Metropolitan Planning Commission

Staff Reports

August 28, 2014

CHURCH STREET TOWNHOMES

Proposed Site Plan

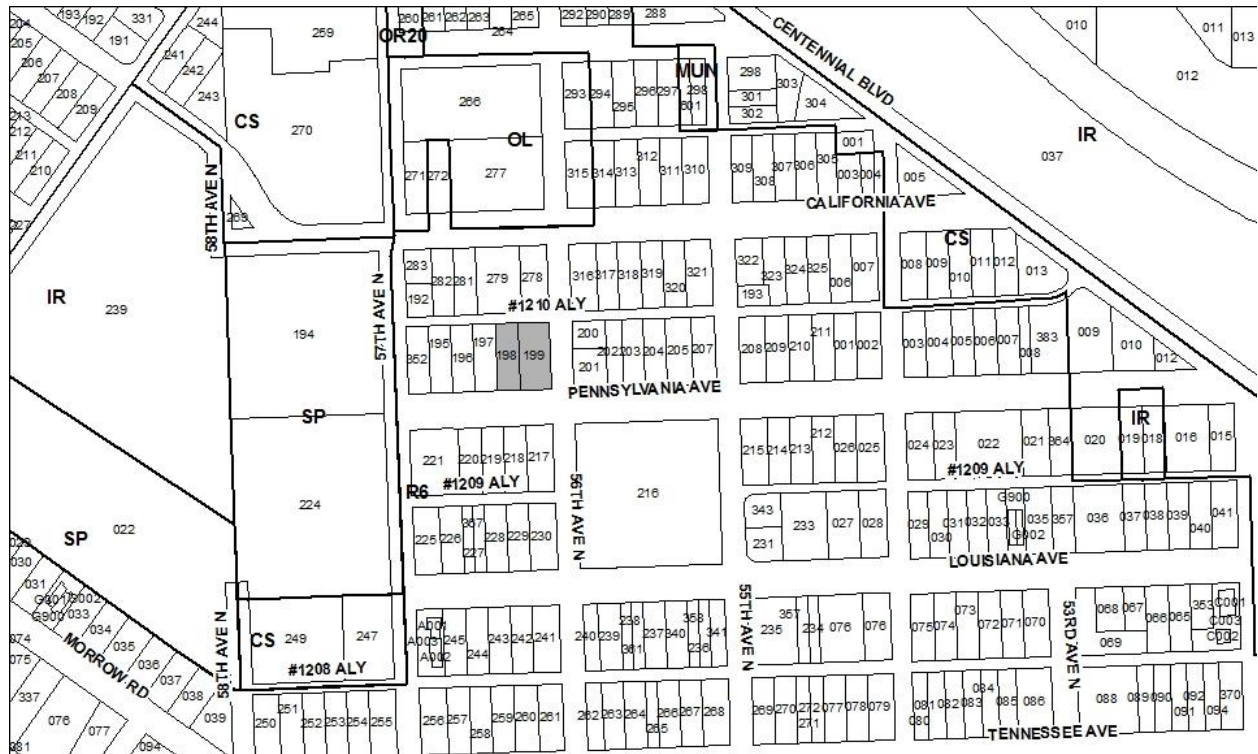
Staff does not find the plan consistent with Suburban Neighborhood Maintenance land use policy. The plan does not provide an adequate transition from the multi-family area west of the site to the single-family area to the east.

Returned for corrections

- Add 78-840 Note.
- For the stream buffers, show and label the most restrictive floodway line. Then show the 50' and 25' zoned buffers. Then show the area that was approved based on the variance.
- Cite the variance number to the plans.
- Add note to plan stating that the stream crossing is to be perpendicular. Show a perpendicular crossing.
- Excess water quality / quantity bypass was observed.
- Add Buffer Note.
- Add Preliminary Note.
- Add Access Note.
- Add C/D Note.

1. Uses shall be limited to 118 residential units.
2. All Public Works and Stormwater changes must be provided on the plan.
3. All Public Works and Stormwater conditions must be met.

4. Prior to the approval of any final site plan any additional ROW along Church Street East or Cloverland needed to meet the Major and Collector Street plan shall be dedicated.

Proposed PUD Plan

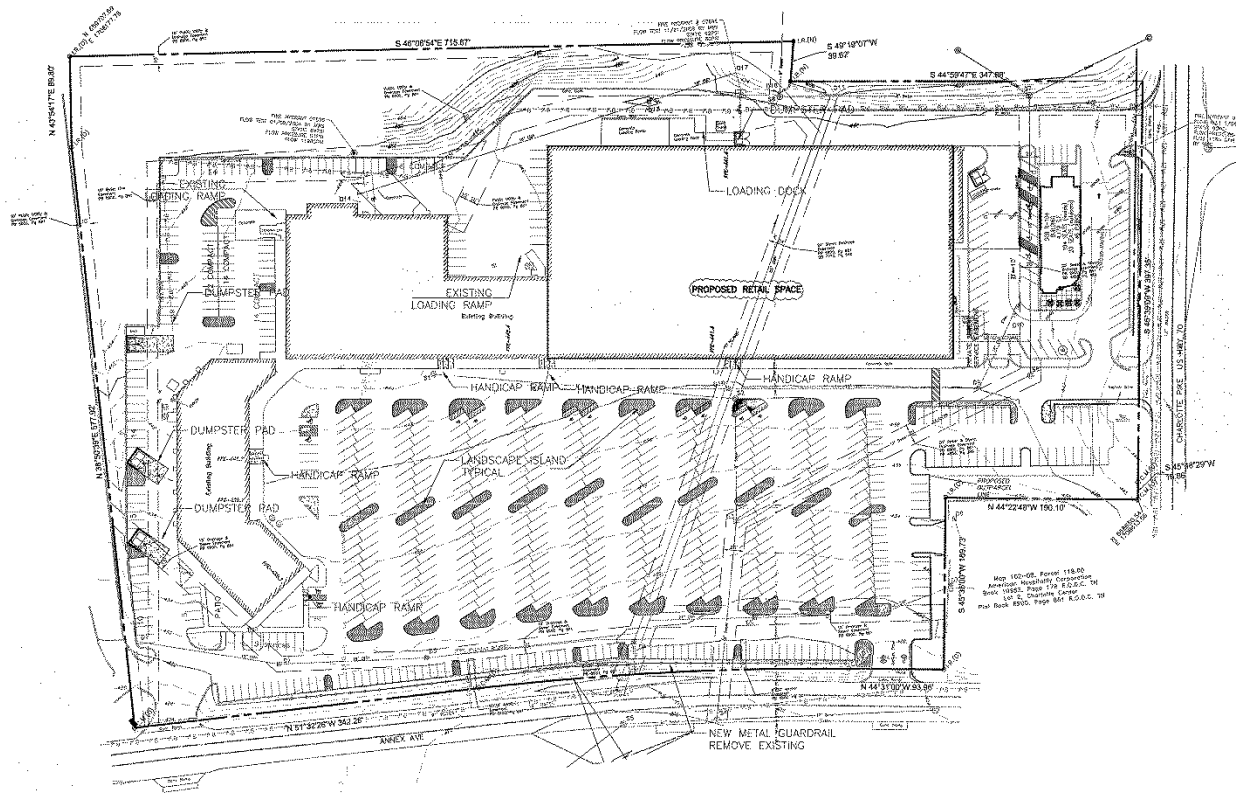
A shared parking study was submitted to the Metro Traffic Engineer. The current plan proposes 716 spaces. Metro Traffic Engineer has not yet approved the shared parking study submitted by the applicant.

- An updated traffic and parking study is required for this proposal.

Staff recommends deferral to the September 11, 2014, Planning Commission meeting if recommendations of approval are not received from Traffic and Parking and Public Works. If recommendations of approval are received, staff recommends approval with conditions.
